SERVICE BULLETIN

M-1408

2014-2015 TOURING SADDLEBAG MOUNT - SAFETY RECALL 0166

Figure 1. Saddlebag Stud Receptacles

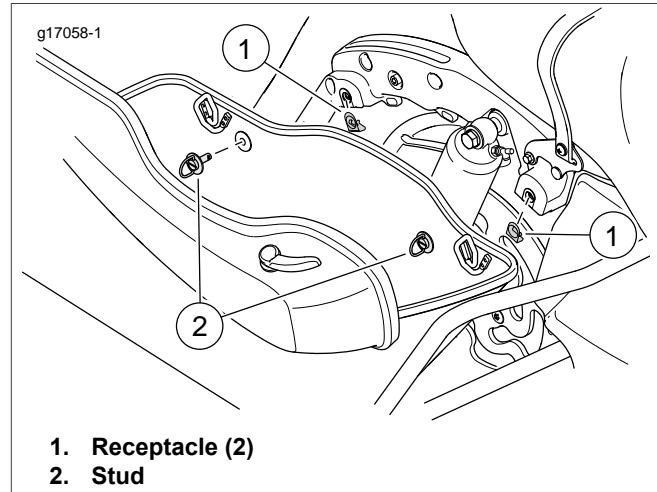
1. Verify that the motorcycle is involved in this recall.
2. See Figure 1. Remove saddlebags.
3. Remove receptacles (1).
 - a. Insert a small screwdriver between receptacle clip and edge of saddlebag support.
 - b. Pry receptacle from saddlebag support.

4. Install **new** receptacles supplied in kit.
5. Install saddlebags using original studs (2) and washers.
6. When returning the motorcycle, remind the owner of the importance reading and following the saddlebag installation instructions provided in the owner's manual.
